City of Portland, Maine – Building or Use Permit Application 389 Congress Street, 04101, Tel: (207) 874-8703, FAX: 874-8716

**Building or Use Permit Pre-Application
Additions/Alterations/Accessory Structures
To Detached Single Family Dwelling**

Proposed Project Description:(Please be as specific as possible)
FAMILY ROOM ADDITION TO EXISTING HOME. 12x15 MM

DATE: 8 DEC. 98 ADDRESS: 43 Wendyway CBL 394-A-058
REASON FOR PERMIT: To Construct a 12'x15' addition
BUILDING OWNER: DR. G. DiGreggretta / Cathy Costaro
CONTRACTOR: Tozier Group Inc.
PERMIT APPLICANT: ↑
USE GROUP R-3 BOCA 1996 CONSTRUCTION TYPE EB

Plot Plan

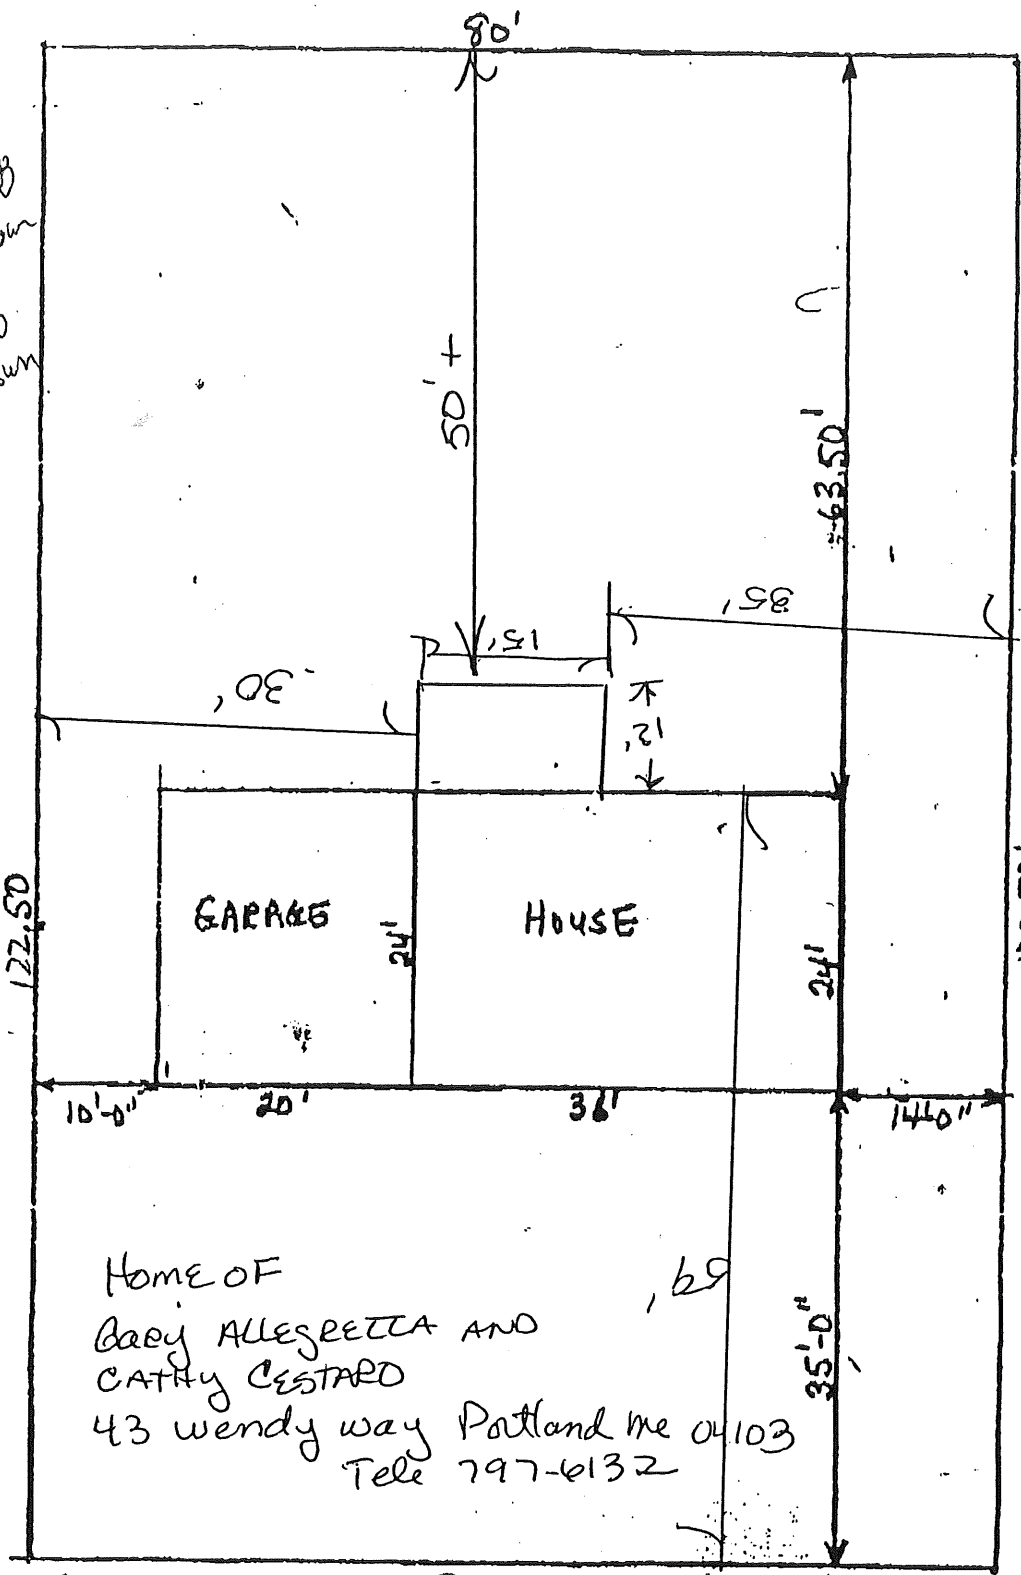
R-2 Zone

Front: N/A
2AR + 25' req
50' shown
side - 12' req
30' 35' shown

LOT = 9800 SF
HOUSE 1344 SF
ADDITION 180 SF

LOT COVERAGE
WITH ADDITION,
15.5%
